Base Fashions Ltd. - New Unit

Observations

Discrepancy between as- built drawings and on site condition

Exposed rebar on column and slab

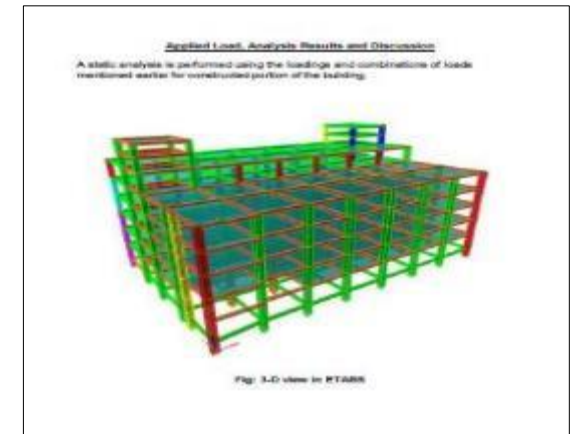
Factory has permit drawing for the 6-storey building and exposed reinforcement in roof indicates the possibility of further extension of the building. For any future extension, a significant increase in column loads may cause. So, design report to be verified for concrete strength as part of Details Engineering Assessment before the commencement of construction additional floor above present condition (5-storey and 3-storey).

18 rebars found in FEA instead of 16 for C6 column

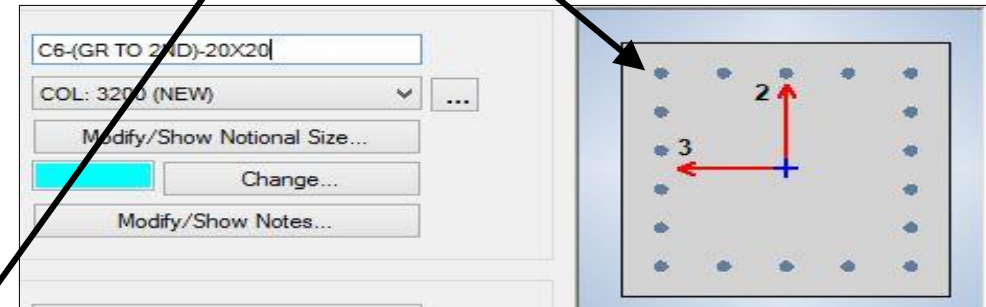
The column layout did not match with provided Finite Element Analysis (FEA) model. Also, the reinforcement of C6 column; size & retrofitting scheme of C5 column did not match. Factory engineer is required to check the drawings and update the FEA accordingly.

Lightweight steel roof rested on the brick walls

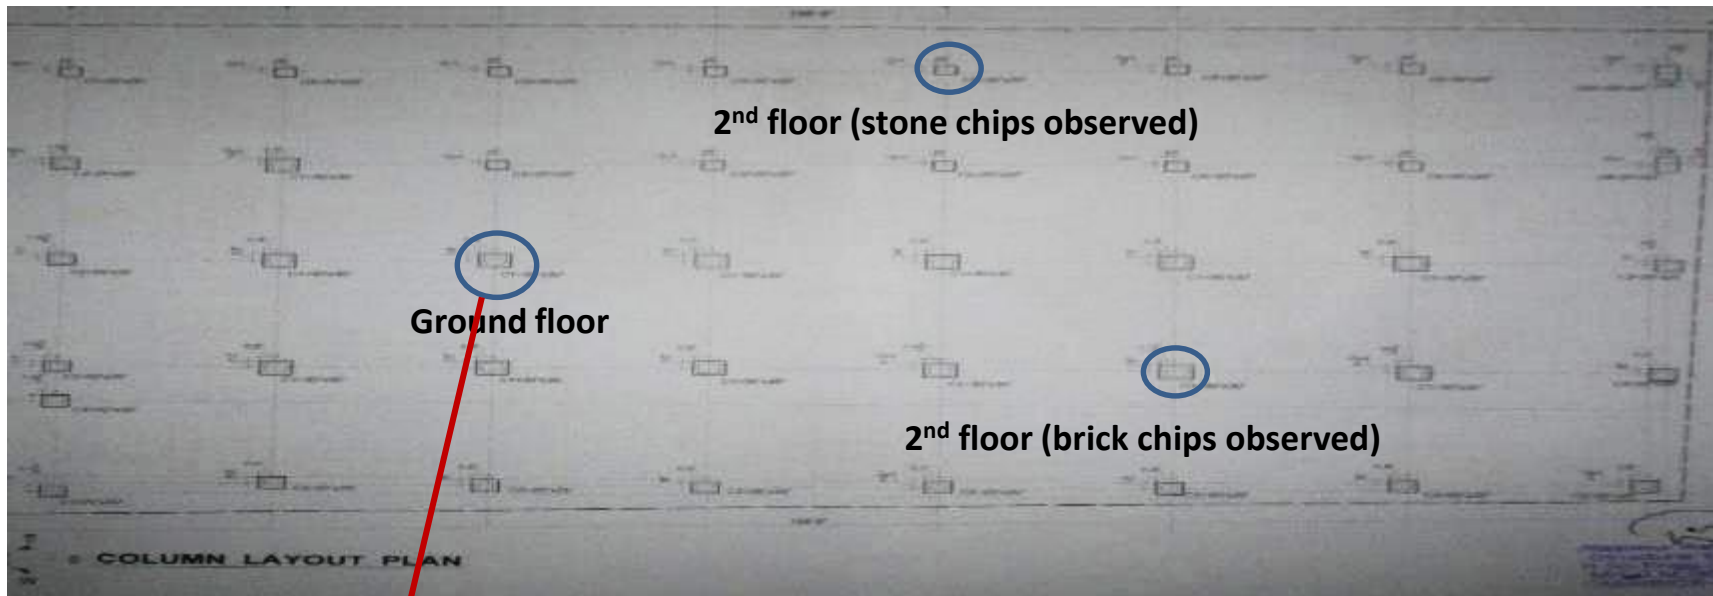
The as-built drawing was not available for generator shed. As-built drawings for the shed to be prepared. Besides, No stability system was observed and the shed seems to be non-engineered. Factory is required to check the adequacy of roof against uplift forces.
